# SERVICE INFORMATION

## NO. SI 42-247

Garmin Service Bulletin No. 22117 Rev. B

NO.: 22117 Rev B

Figure 1 - 233-00075-01 and 233-00075-02 Cable Retention Pins

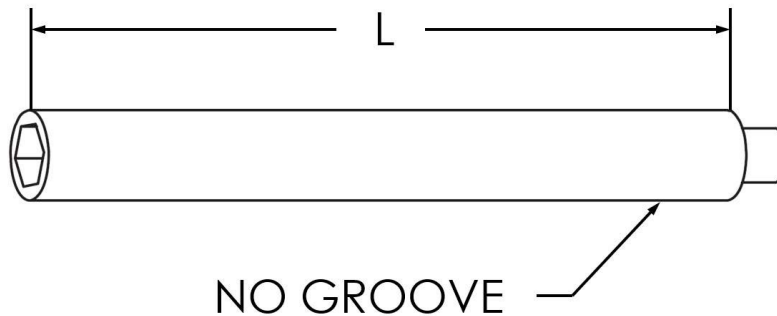
Garmin has issued Service Bulletin No. 22117 Rev. B recommending replacement of the cable retention pins with new longer cable retention pins at the GSM 86 servo gearbox assembly.

Both the -01 and -02 Cable Retention Pins have no grooves (See Figure 1). The -01 Cable Retention Pin is 1.48" long and the -02 is 1.60" long (See Figure 1).

This Service Bulletin contains instructions to replace the cable retention pins with new longer cable retention pins to ensure the GSM servo gearbox capstan is free to rotate in the event that the clutch retaining bolt is not retained.

**Figure 4 - New Cable Retention Pins**

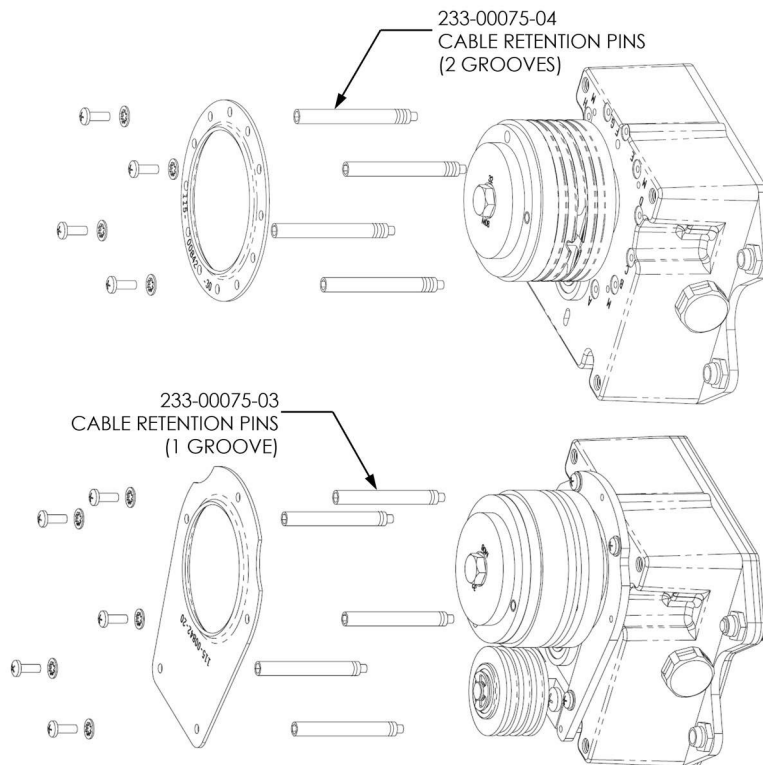
1. Refer to the applicable airframe specific maintenance manual to gain access to the GSM 86.
2. Gain access to the cable guard pins by removing cable guard hardware including screws, washers, and top ring.
3. Replace each cable retention pin with a new part number as listed in Table 1.

<b>New Pin P/N</b>	<b>Replaces Pin P/N</b>
233-00075-03 (one groove)	233-00075-01 (1.48")
233-00075-04 (two grooves)	233-00075-02 (1.60")

4. Make sure the same hole locations are used as the existing cable guard pins and torque to 6-8 in-lbs.
5. Install the removed cable guard hardware and torque screws to 6-8 in-lbs.
